FIELD CHANGE DIRECTIVE
No. 10-Rev. 1

PROJECT: Truman Waterfront Park Phase 1A

FCD-10 Hardscape Revisions

August 22, 2016

DRAWING TITLE:
**ROADWAY PLAN &
PROFILE**

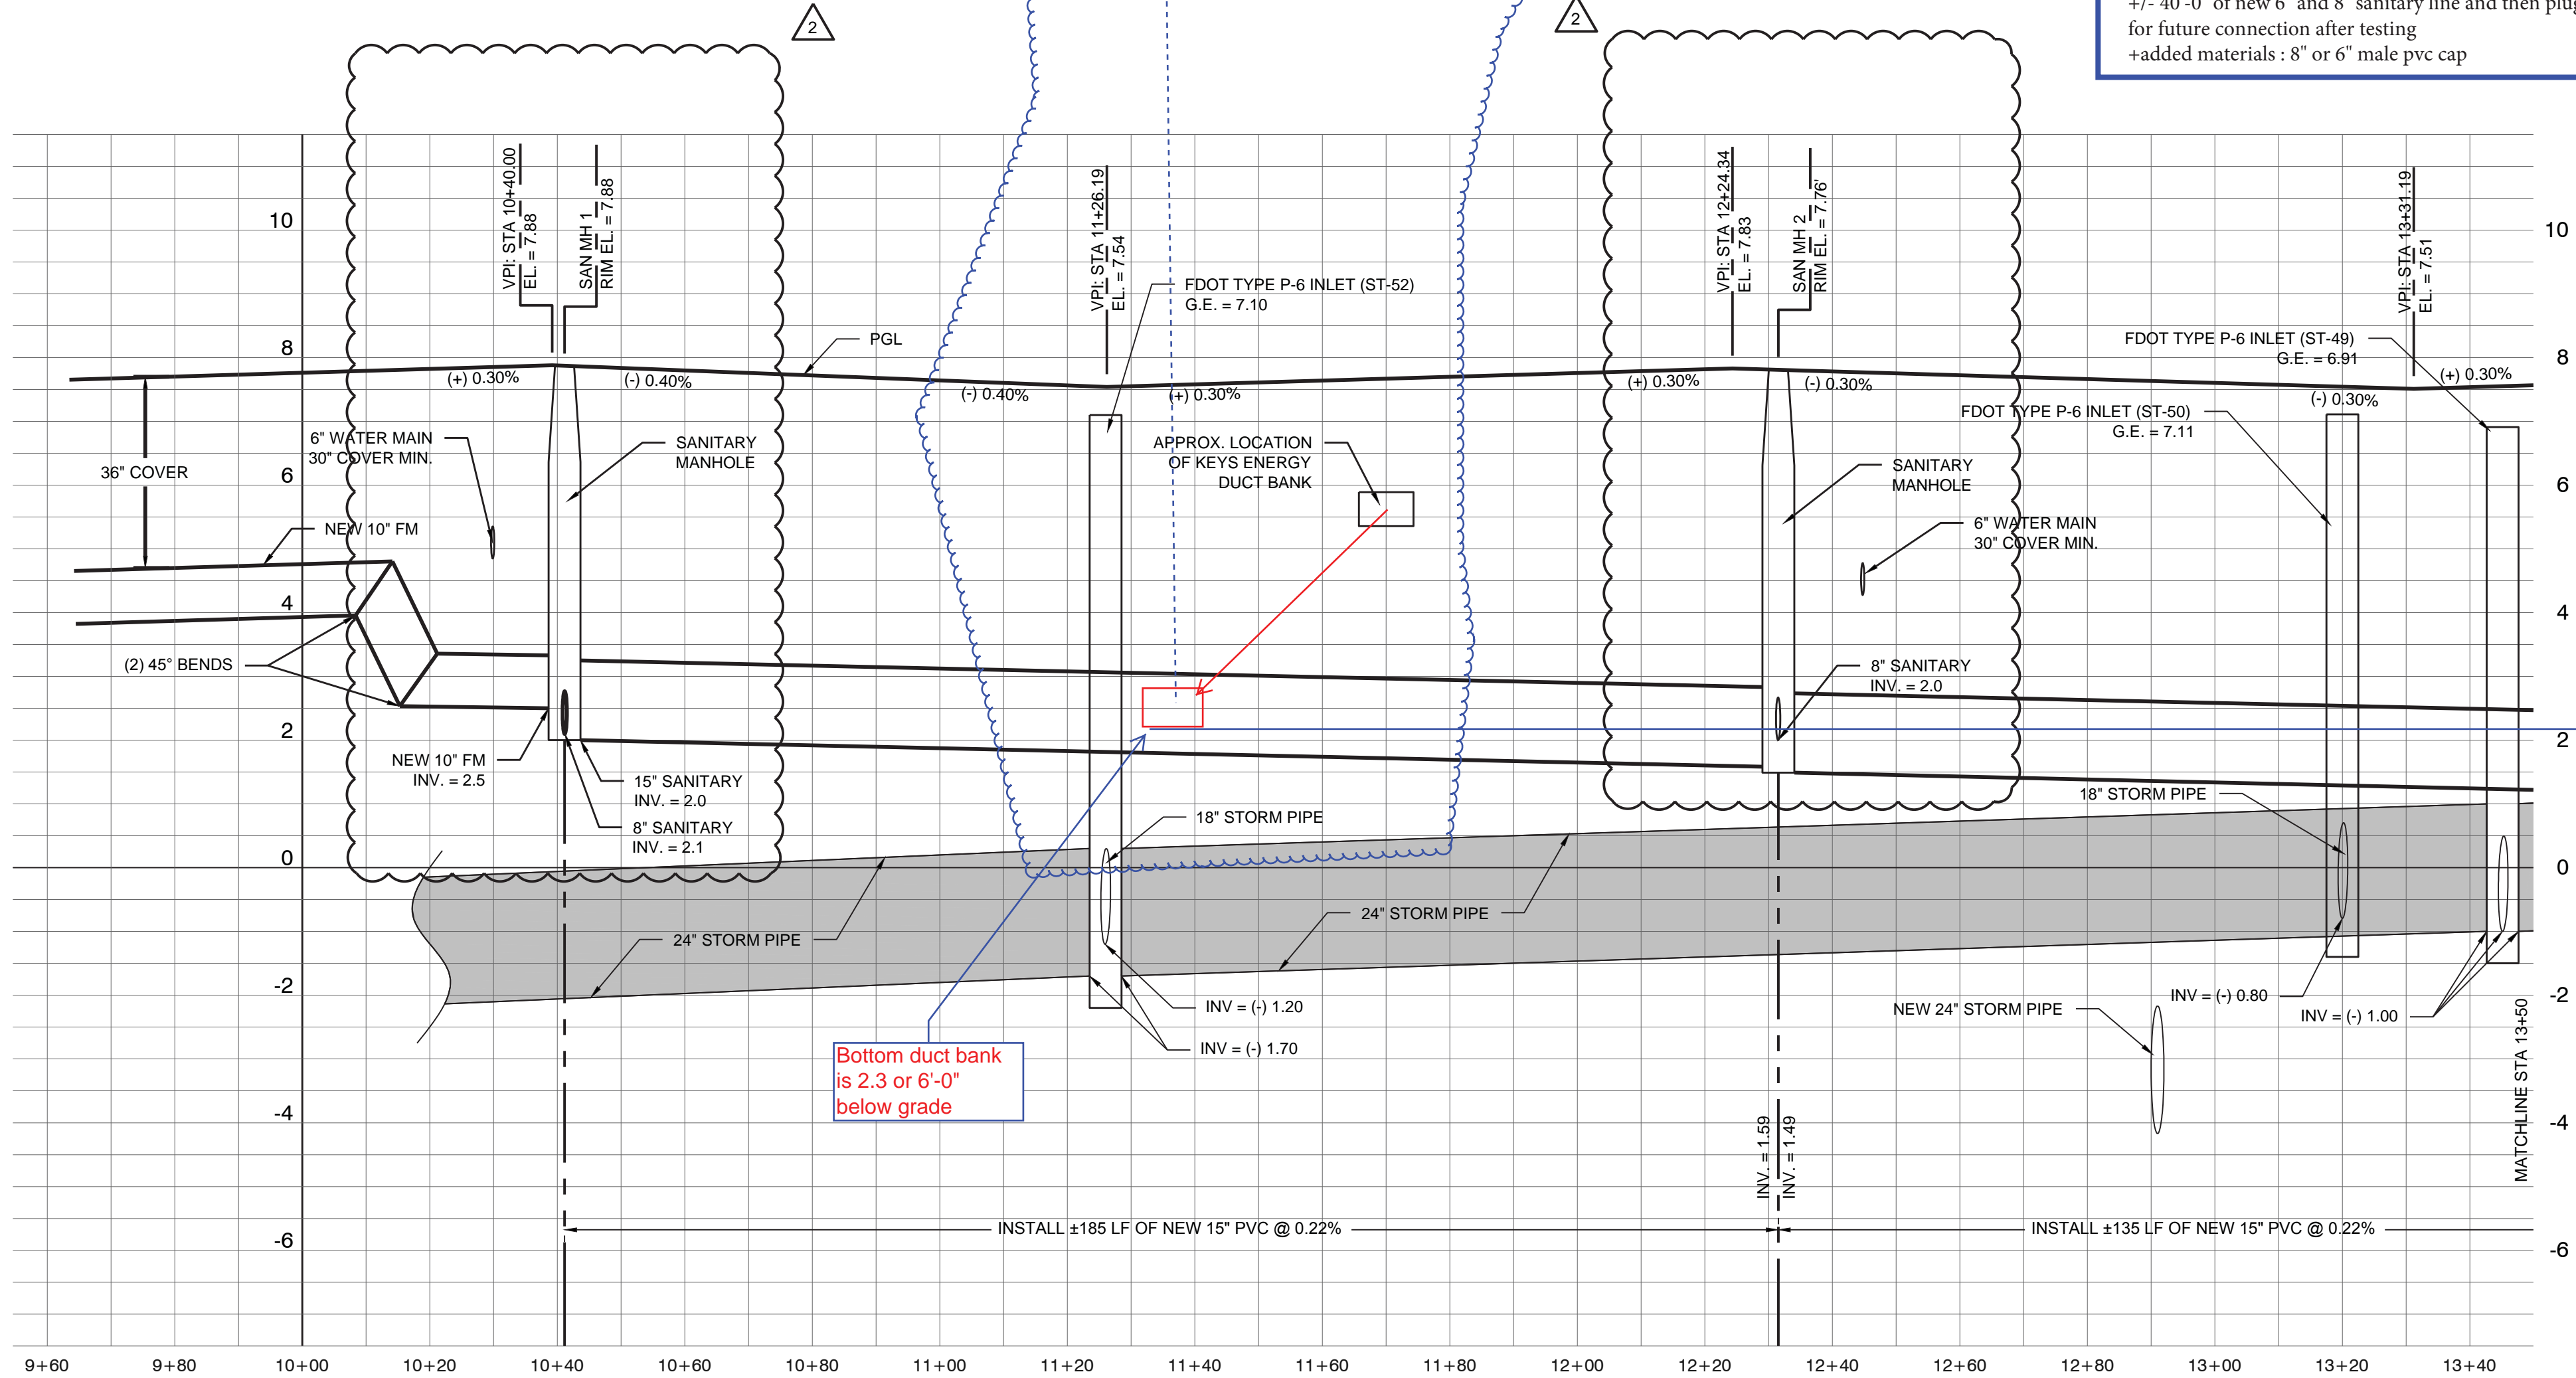
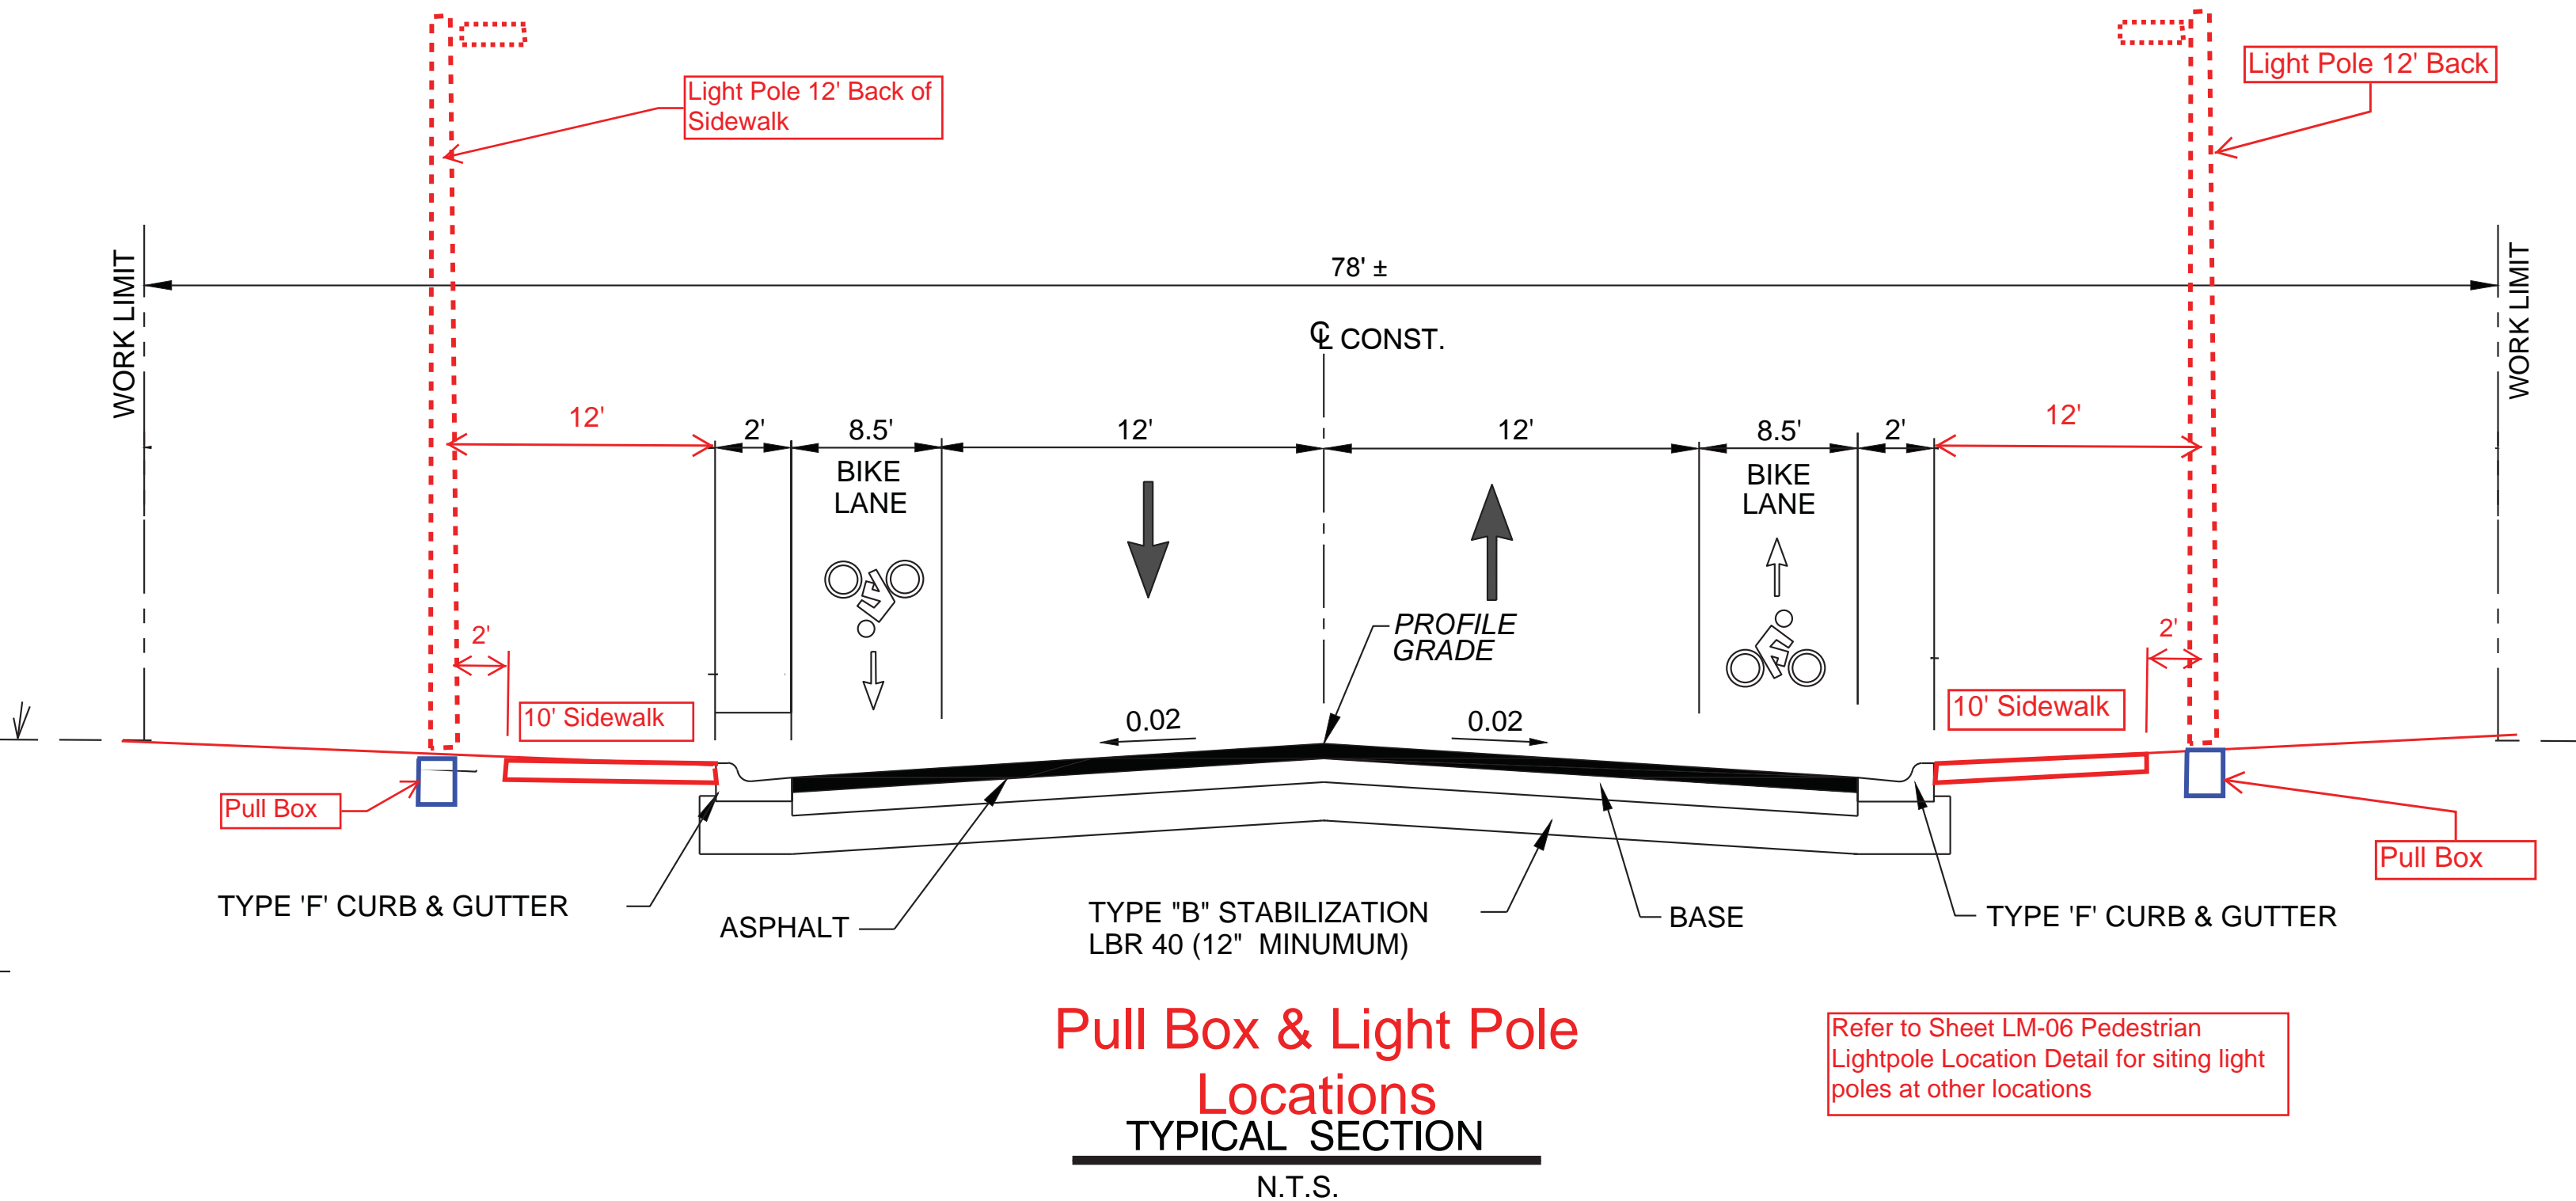
1. Upsized 6" SS lateral to 8"
2. Upsized lateral relocated to other side of ST-51
3. Install three (3) 8x8 clean out assemblies added for 8" SS laterals (prior 1 was a 6" lateral per plan)

4. Keys Energy high voltage duct bank conflict Add +/-100' FM to relocated SSMH 1; Delete +/-100 LF of Sanitary Sewer main.
5. Valley Inlet modification added to ST-51
